From: Marion Read, Landscape Architect

Subject: Plan Change 44 – Hanley Downs. Landscape and visual amenity issues relating to the

amended plan change proposal.

Date: 19<sup>th</sup> June 2015

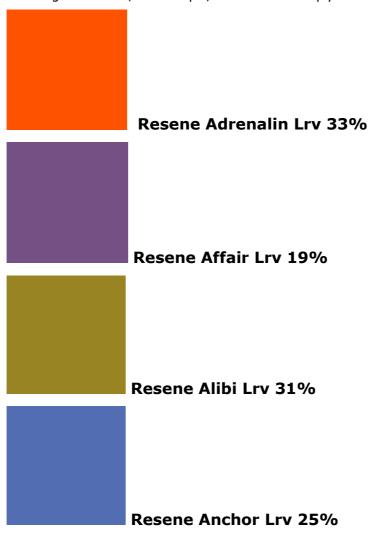
I am concerned that these standards would allow for a dwelling to be constructed within the ONL(WB) portion of FB-1 or within FB-2 which was 30% white. Also, it would allow the use of a wide range of colours which, while they would probably be entirely appropriate within the urban part of the site, would not be appropriate in the elevated parts of the landscape. The following are colours, for example, which would comply:

I consider that limiting the range of colours, as well as the reflectivity, would be necessary in order for residential development within elevated parts of the site to blend into their context and to appear recessive and in keeping with the established character of Jacks Point. Further, I consider that if residential development is to be allowed within the ONL(WB) portions of the site that it should be managed in a similar manner to the Home Sites. I also consider that roof colours could be in the range of browns, greens and greys, but that black should not be included. True black very rarely occurs in the landscape and is more prominent than dark greys.
